## **ADDENDUM #1**

### **VERNON HILLS PARK DISTRICT 2024 TCW Lazy River Pump and Filter Replacement Bid**

Prepared by WT Group

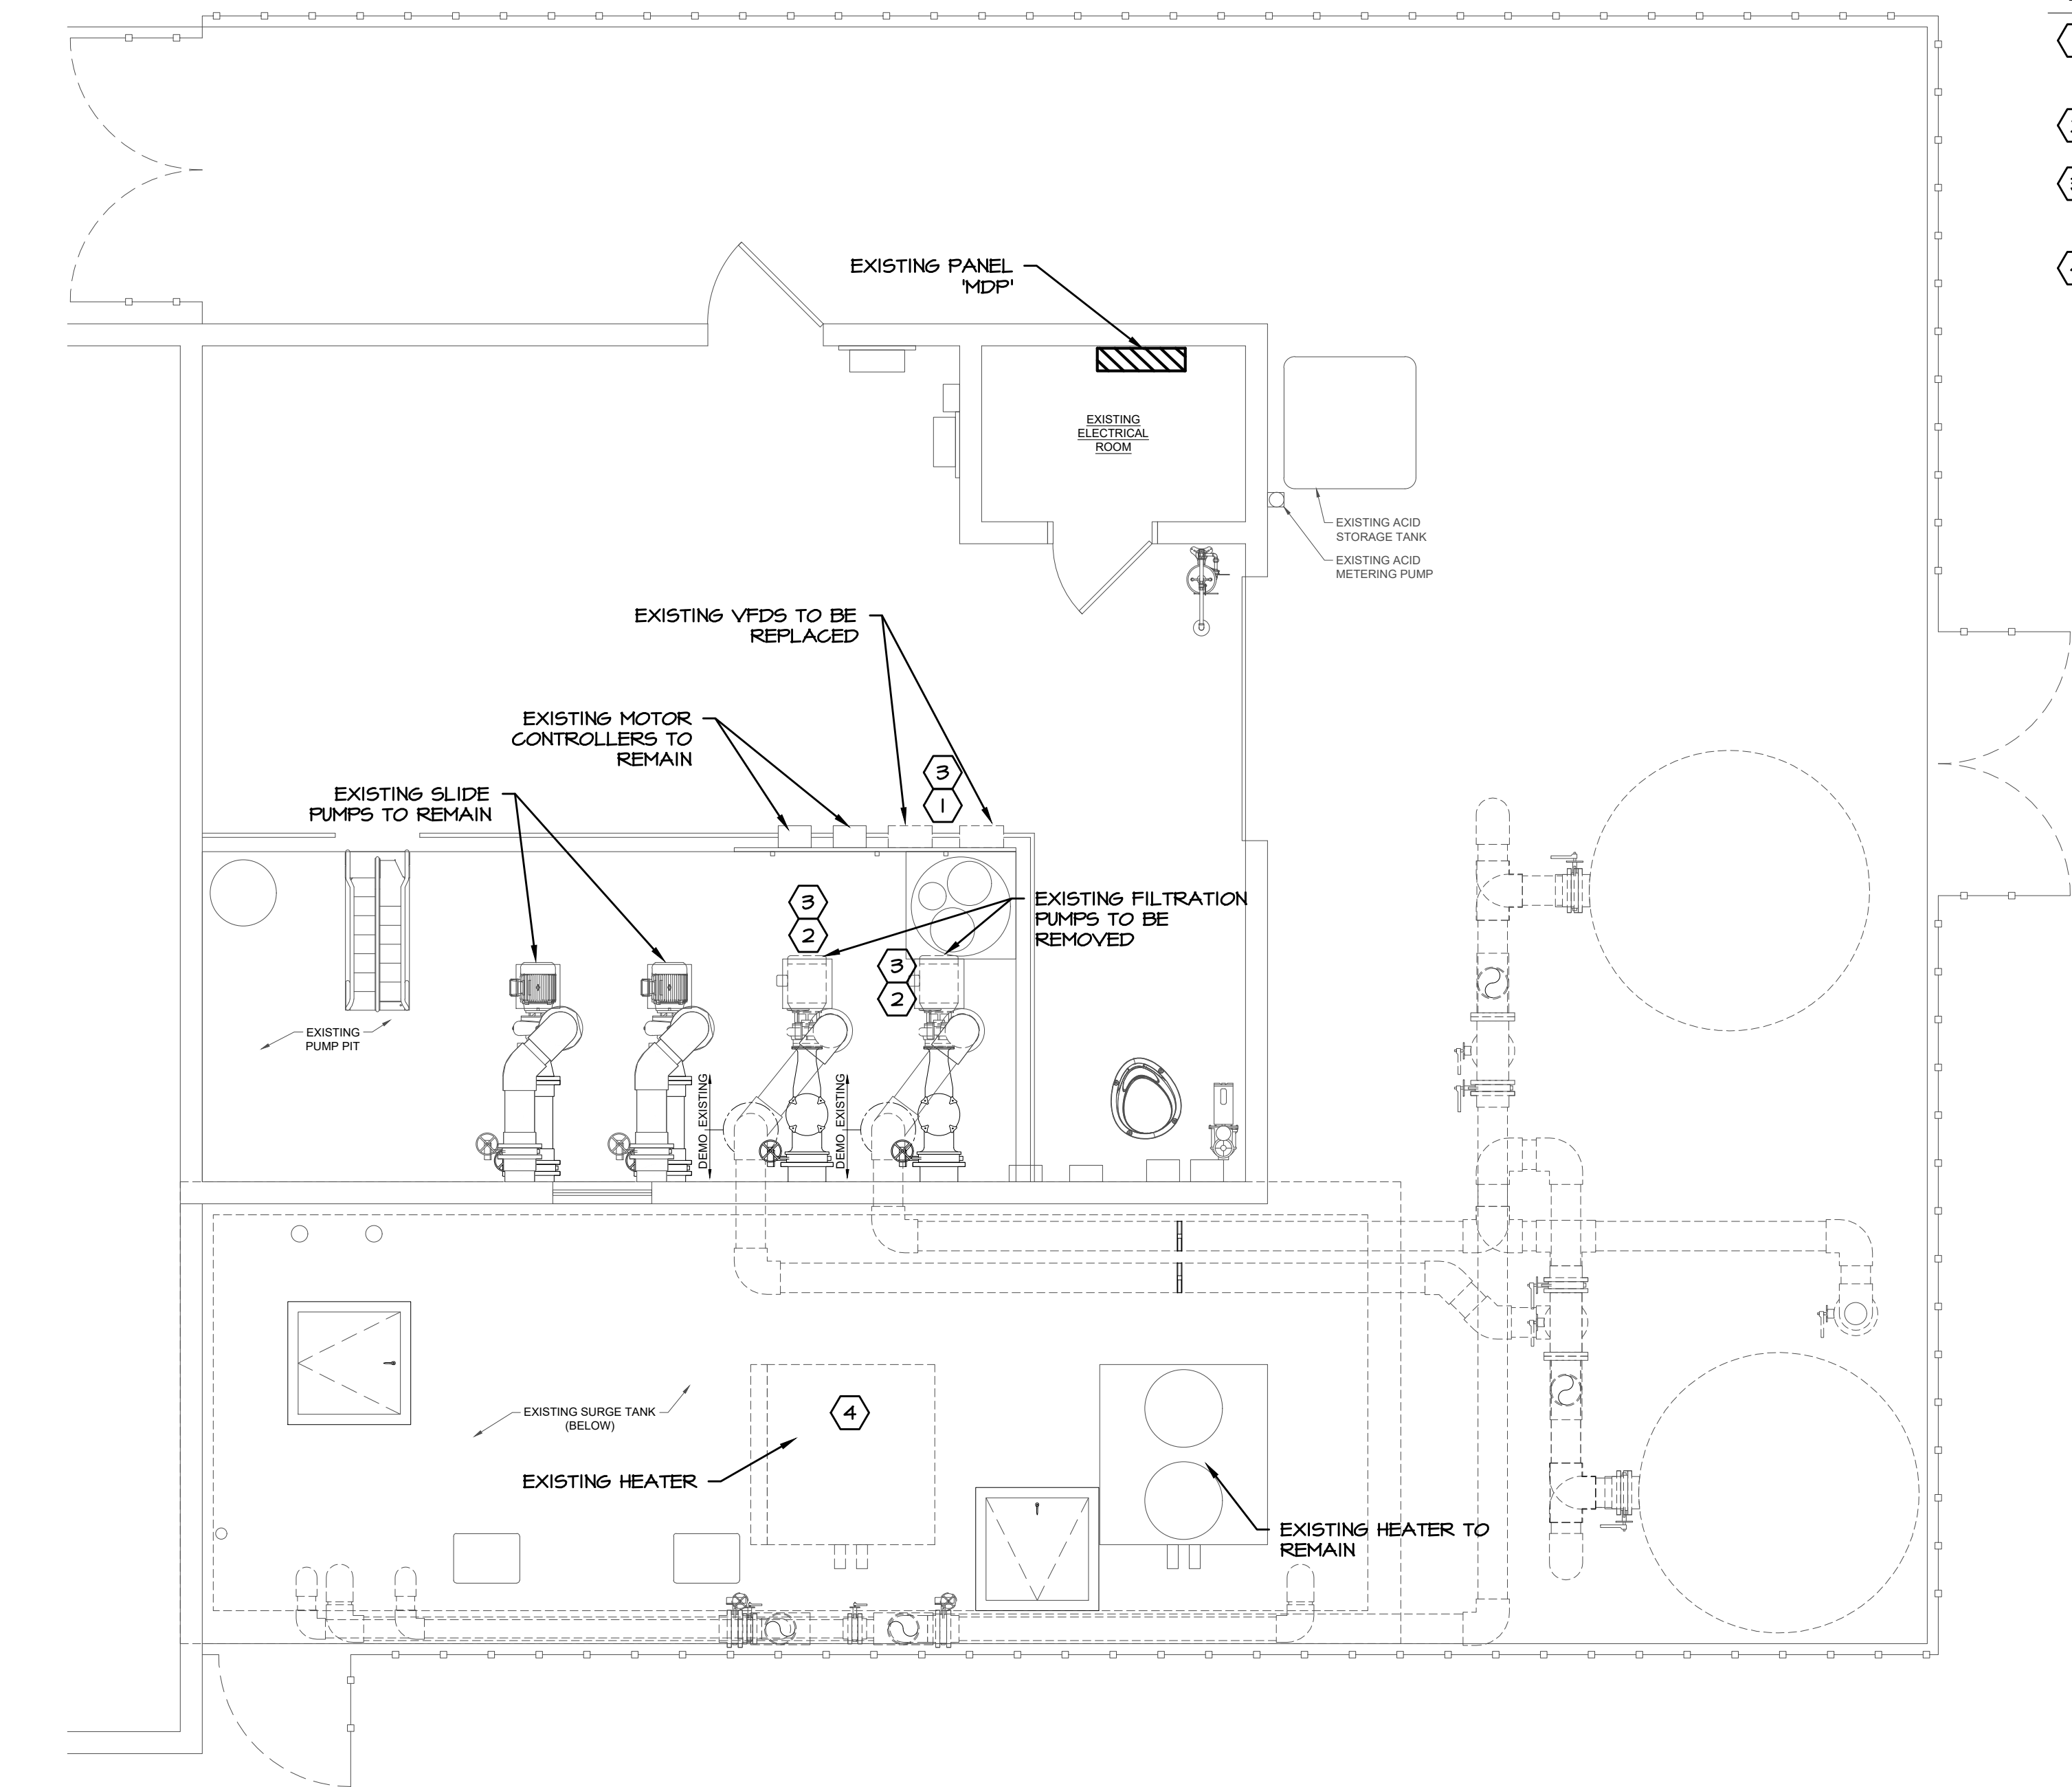
3. QUESTION - Do you have a picture of the existing MDP so I can quote the correct breaker type?

ANSWER – See attached photo.

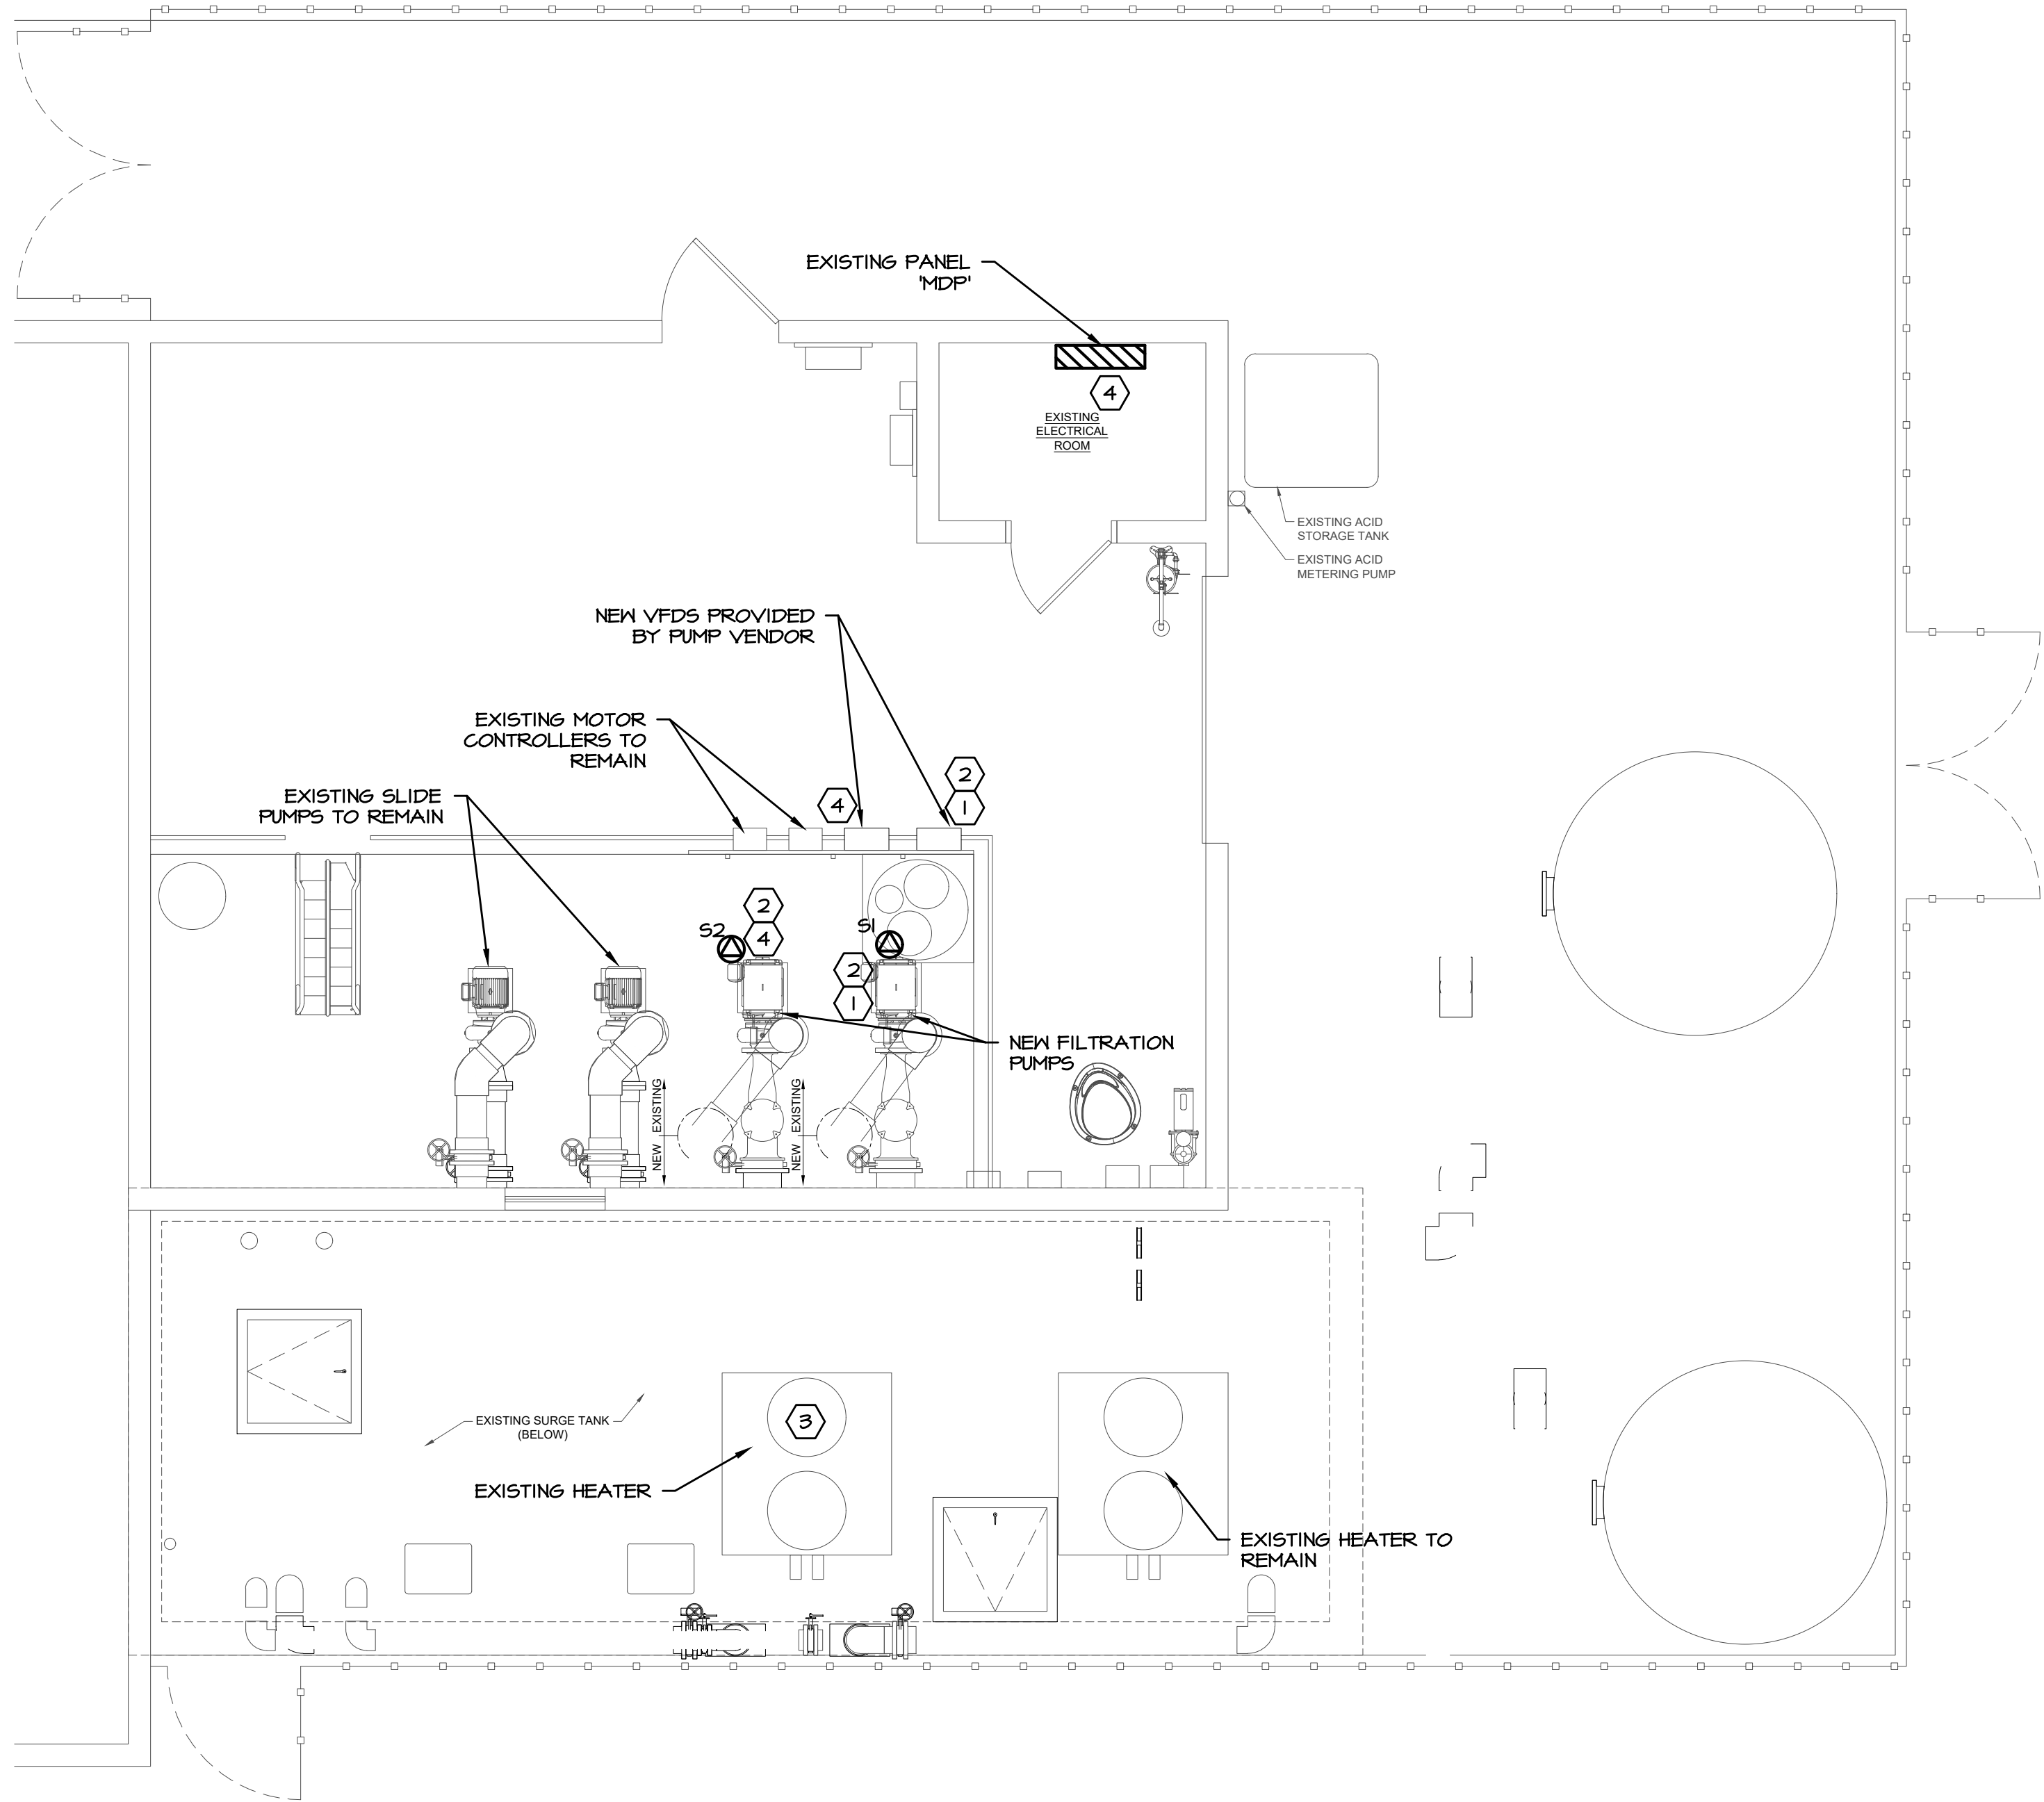
1. COMMENT – Drawing There are (2) Special outlet shown on the schedule on E1.1. The breakers size is 90A/3P, Voltage is 480V. It looks like on the MDP schedule the draw is 52A.  
ANSWER – 52 is Full Load Amps, not starting amps. This is correct breaker sized per code. 40hp motor requires a 90A breaker.
